encana natural gas				
SWAN COMPRESSOR STATION LSD: c-12-B/93-P-9				
1000 bbl HYDROCARBON LIQUID STORAGE VESSEL V-615				
JOB#	DRAWN	DATE	DRAWING NO.	REV.
ENC-112	AABJ	29/03/12	ENC-112-PI-02	12

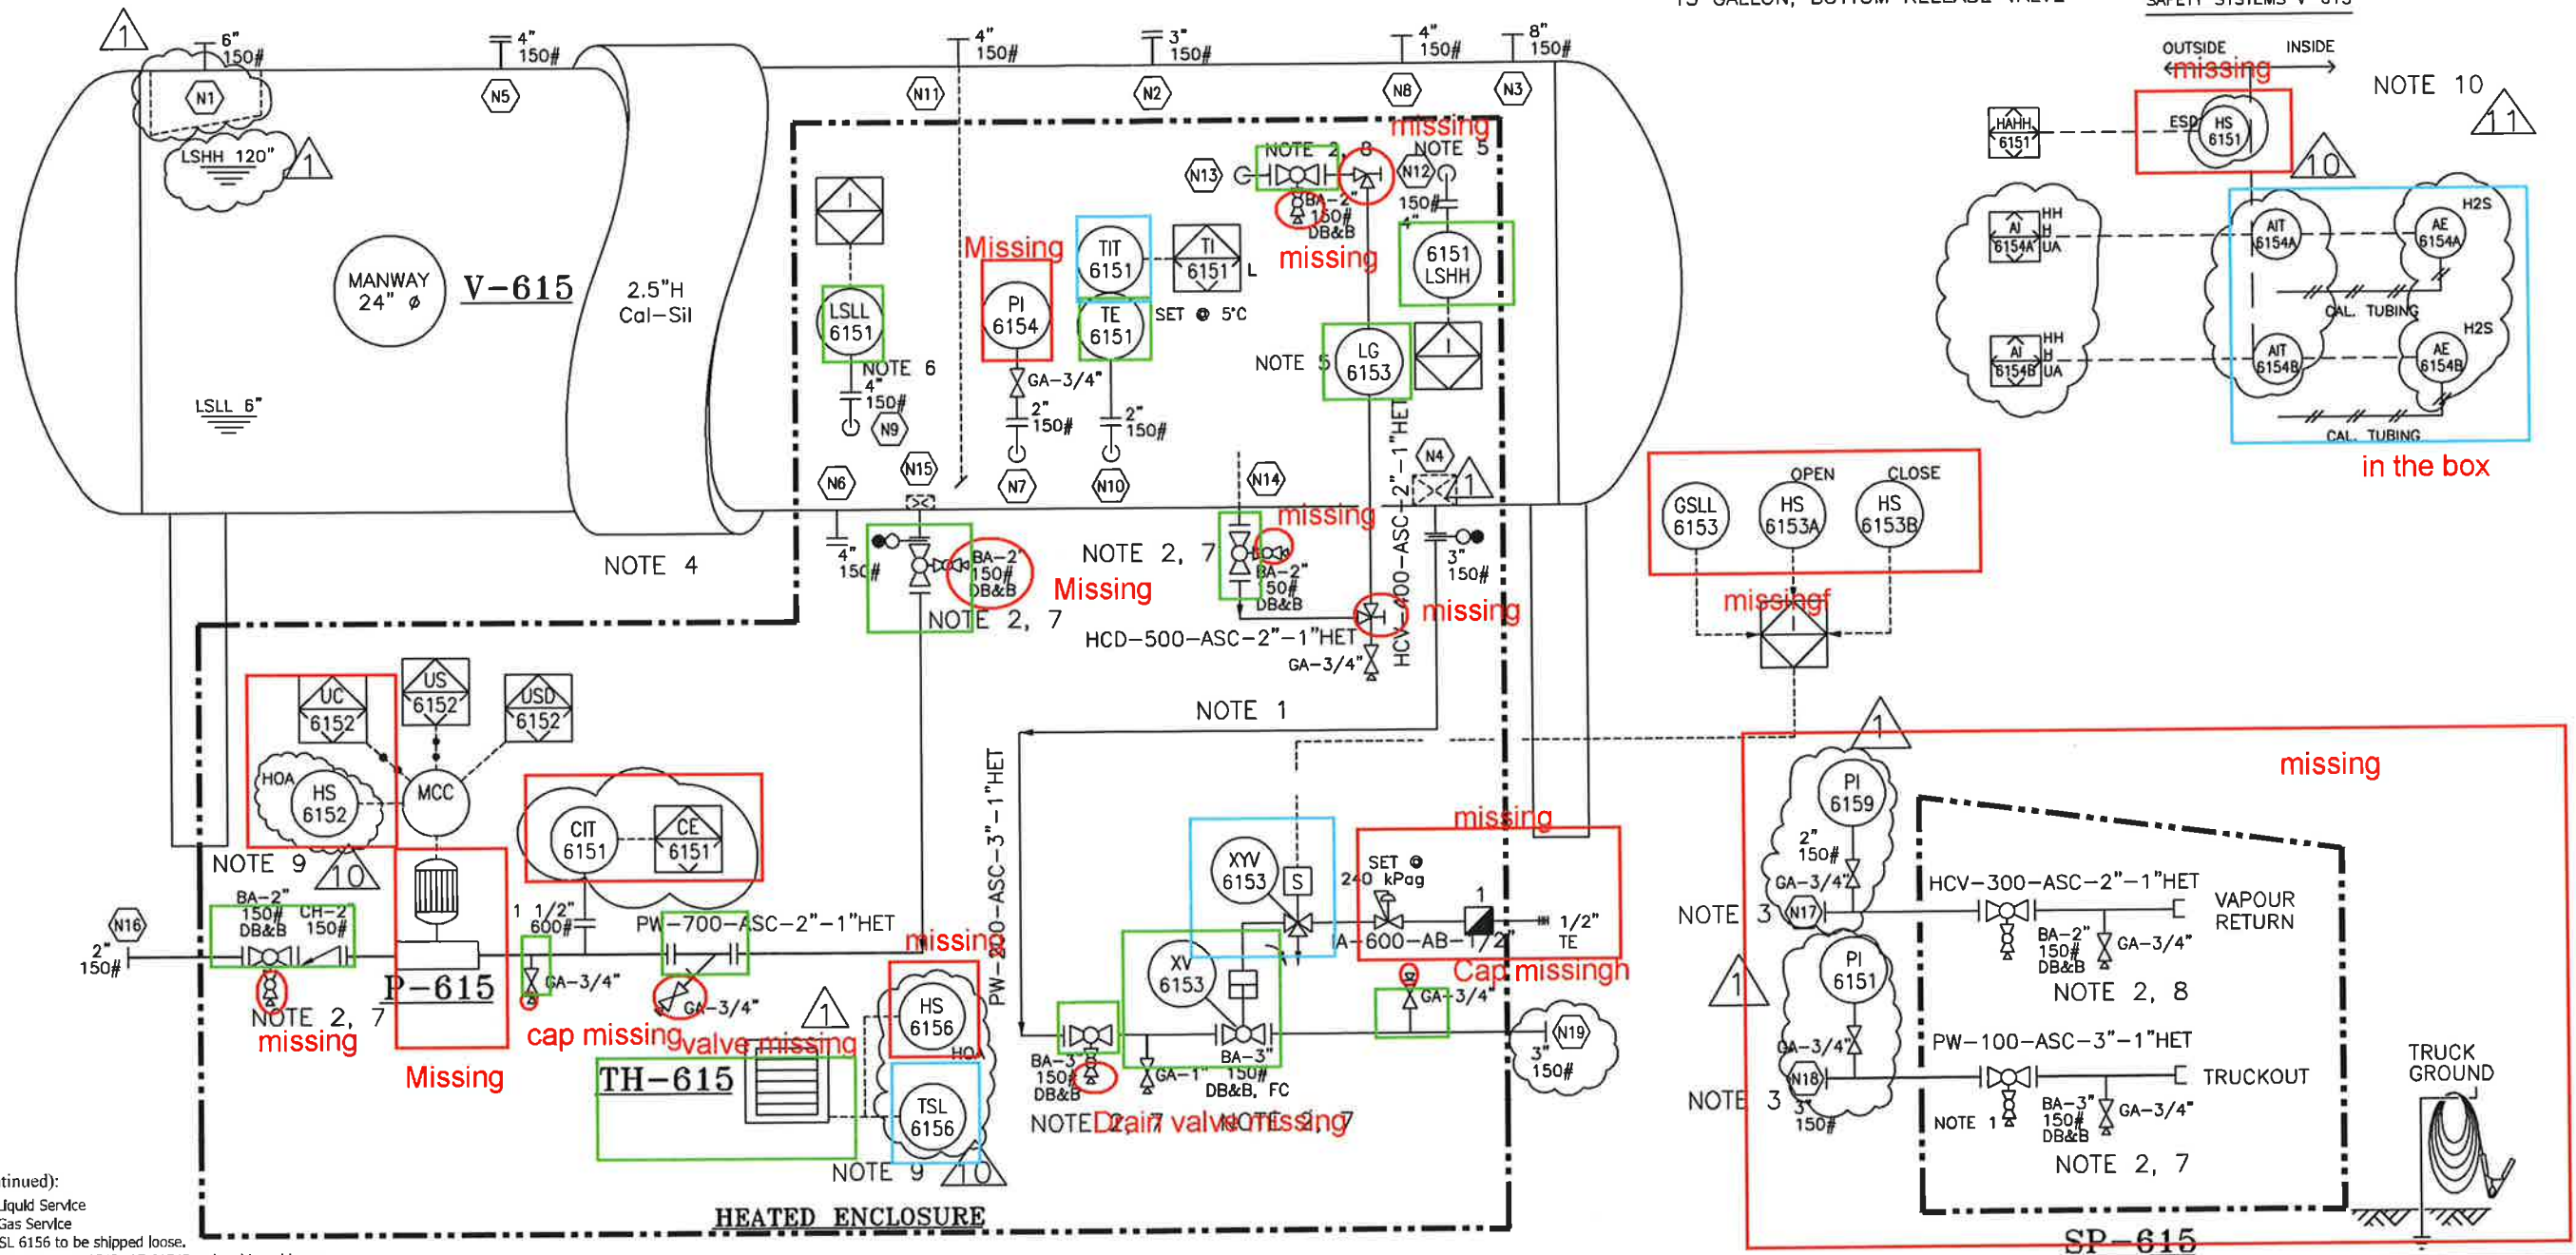
Note: Most of the drain valves were missing as marked
 All the ball valve handles are missing
 Blue means: Ship loose
 Green means: installed
 Red means: missing
